CITY LINK TRUCKING

Construction Drawings

El Paso County, Colorado

TITLE SHEET

EROSION CONTROL DETAILS

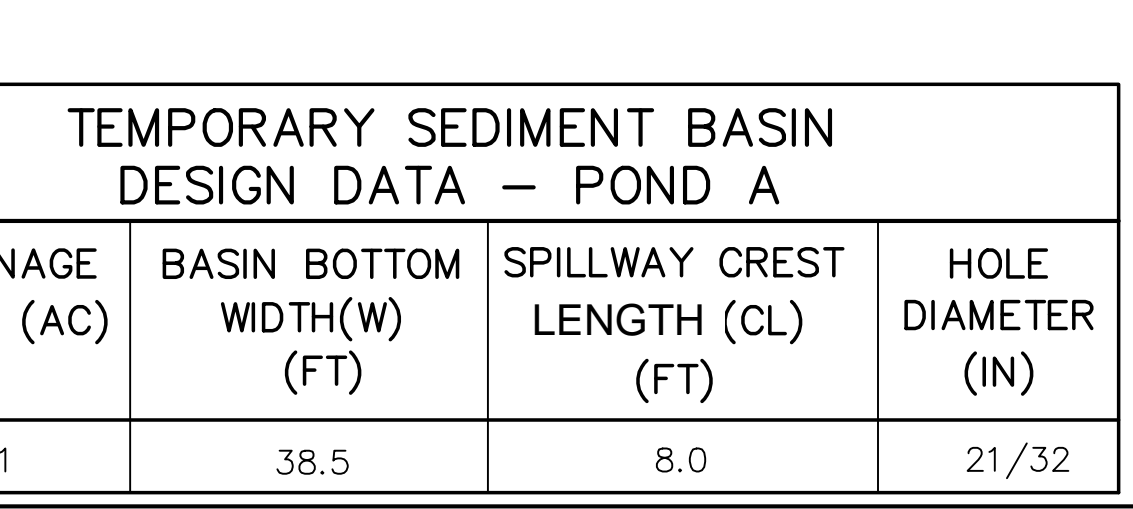
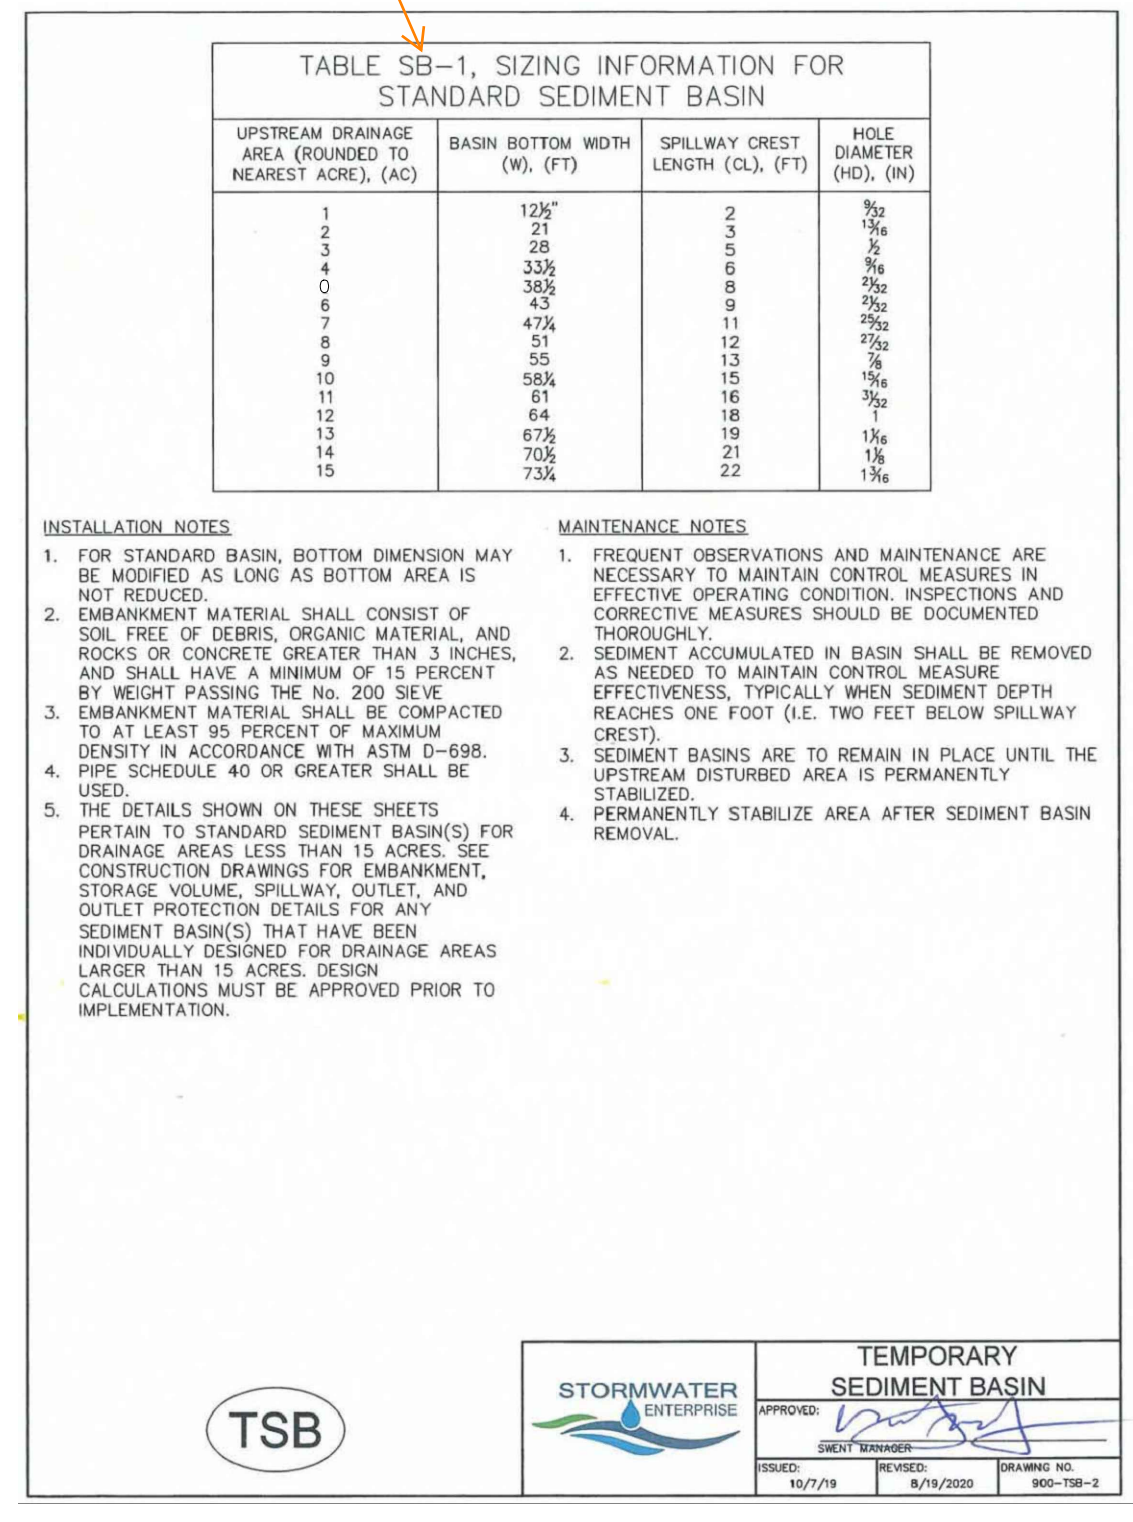
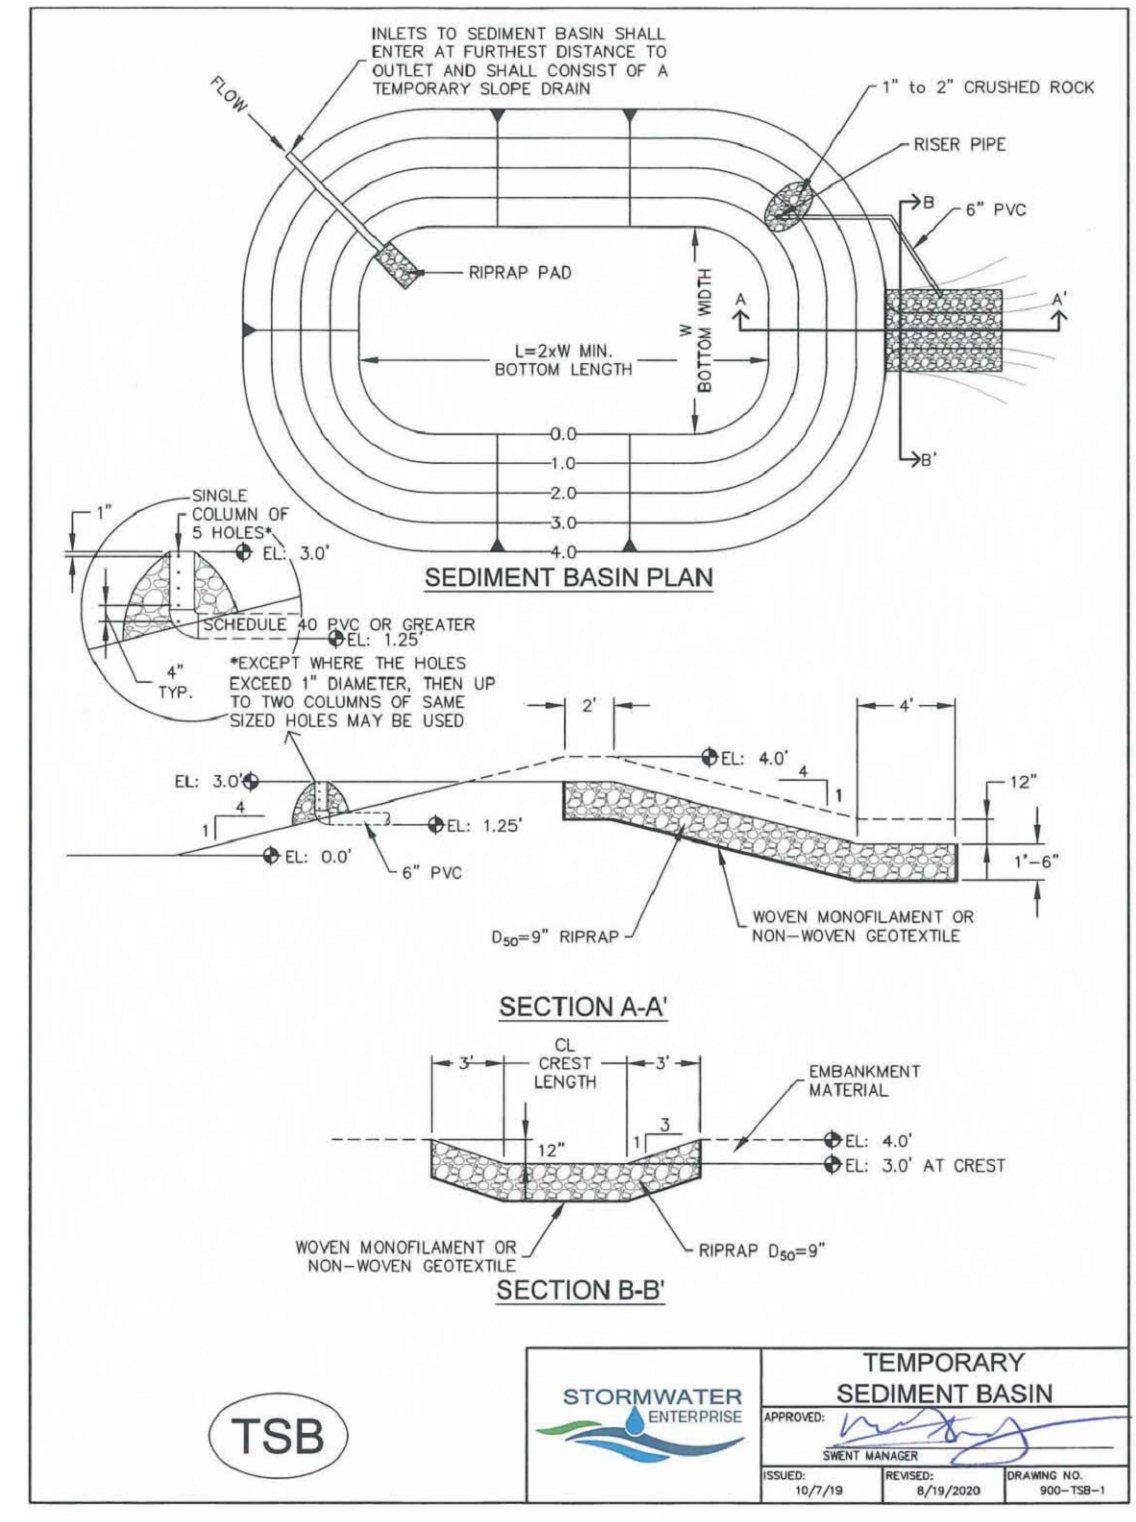
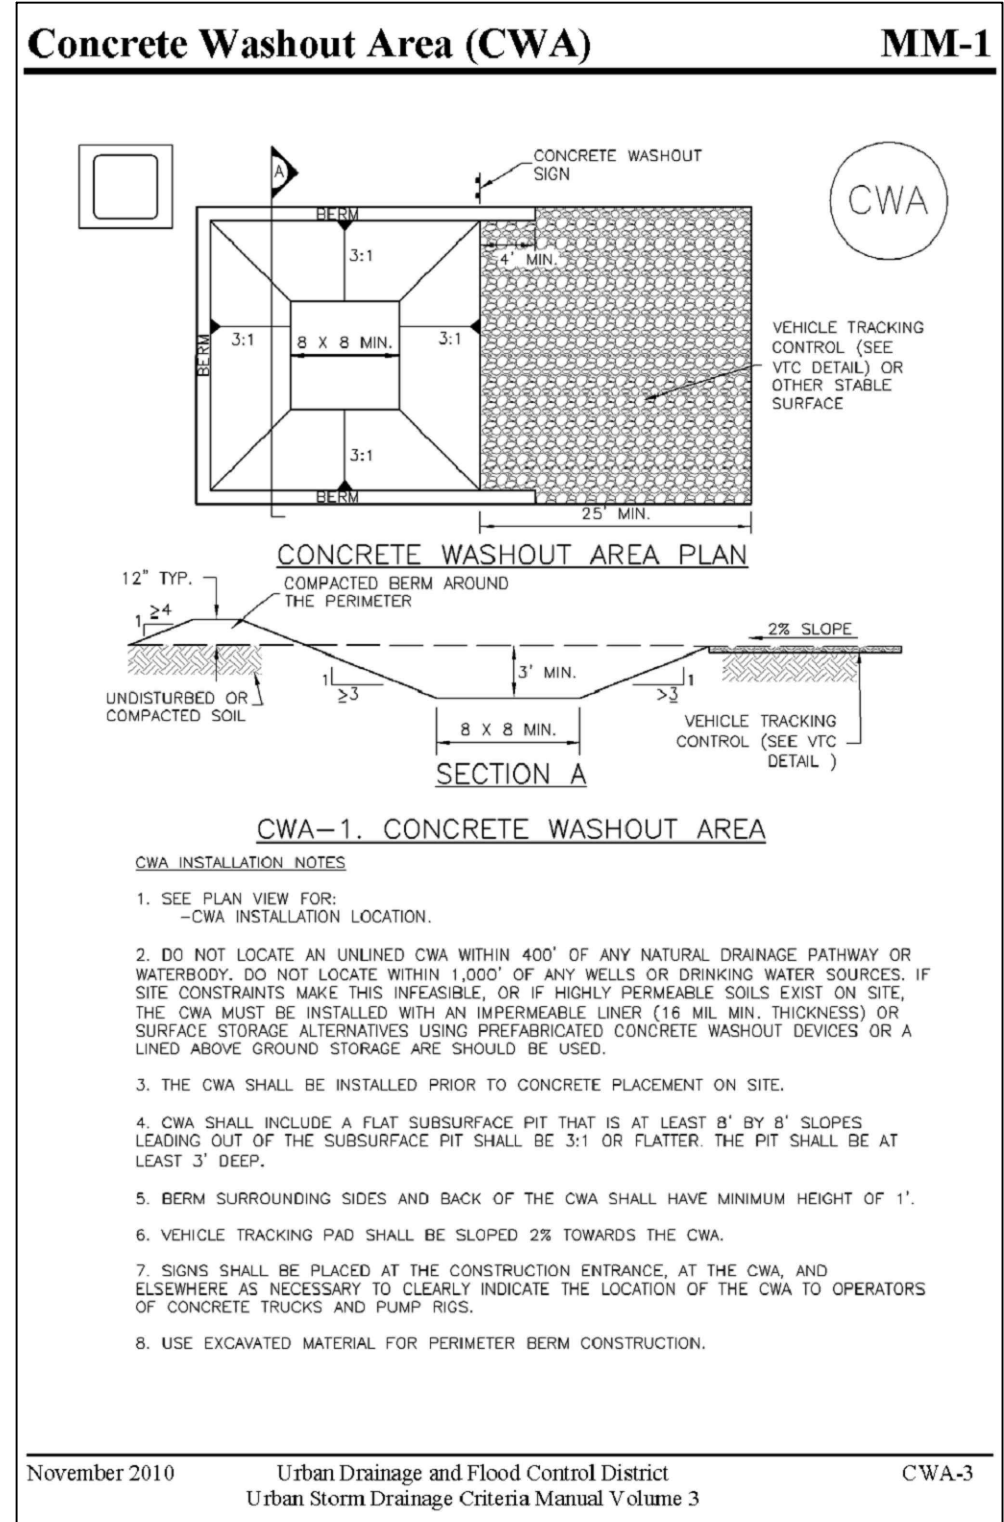
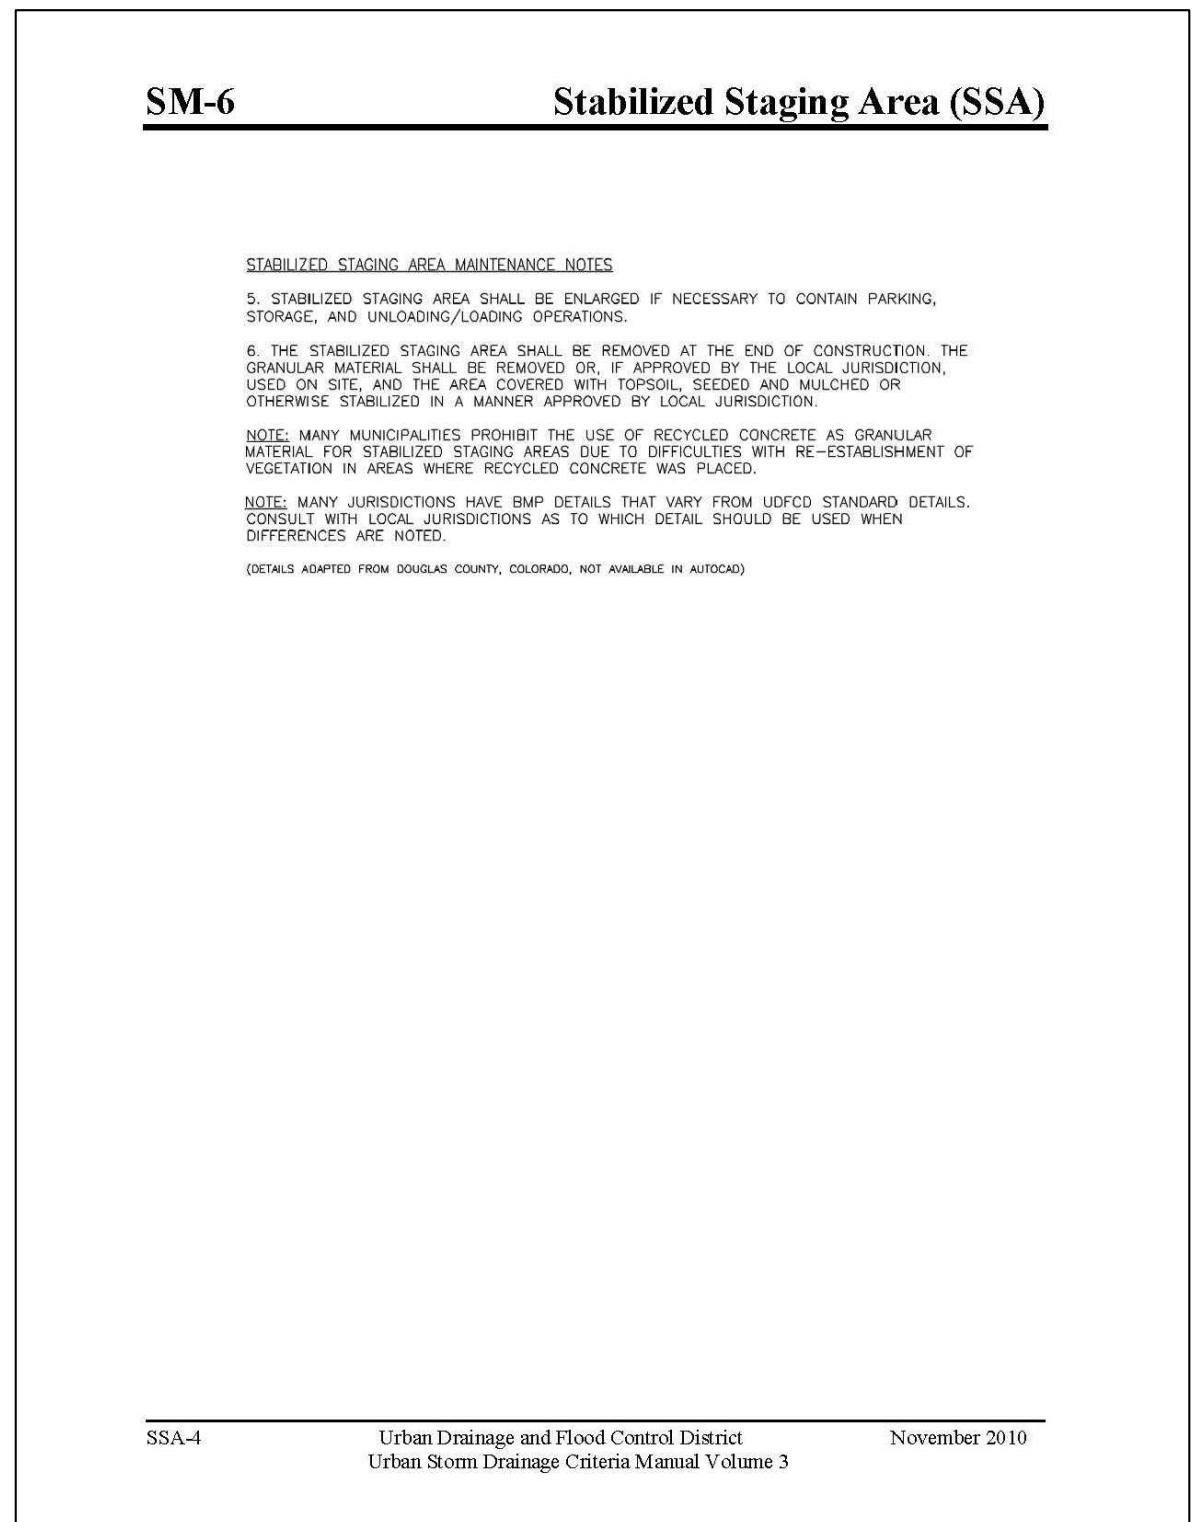
Comment generated due to changes from the previous submittal. Identify what rows are being used so it is clear what dimensions are proposed and the riser pipe details.
